# Access Compliance Report

## Public Rights-of-Way

| Intersection ID: 28284                  | Main Street: LANDING_GREEN_DR | Cross Street: TOLLAND_LN                | Location: W            |
| ADA ID: 23845DFF231C                    | Ramp Type: BlendTrans1        | Initial Pass/Fail: Pass                 | Overall Compliance: No |

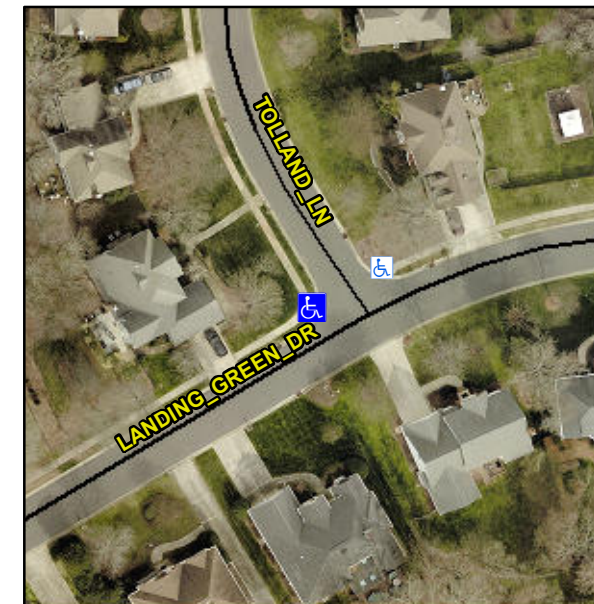
**Not Found, R304.2.2-Perp, R304.3.2-Para, R305.2, R302.7.2**

| Compliance | Description           | Data   | Compliance | Description                 | Data   |
|------------|-----------------------|--------|------------|-----------------------------|--------|
| No         | Landing Slope (%)     | 3.4    | Yes        | DWS Length (in)             | 24.5   |
| N/A        | Landing Curb? (Y/N)   | No     | No         | DWS Offset (in)             | 2.5    |
| No         | Gutter Lip Ht (in)    | 0.5    | Yes        | Gutter X Slope (%)          | 0.2    |
|            |                       |        | No         | Curb Slope (%)              | 12.7   |

**Remove & Replace Curb Ramp With Two New Directional Ramps or Equivalent.**
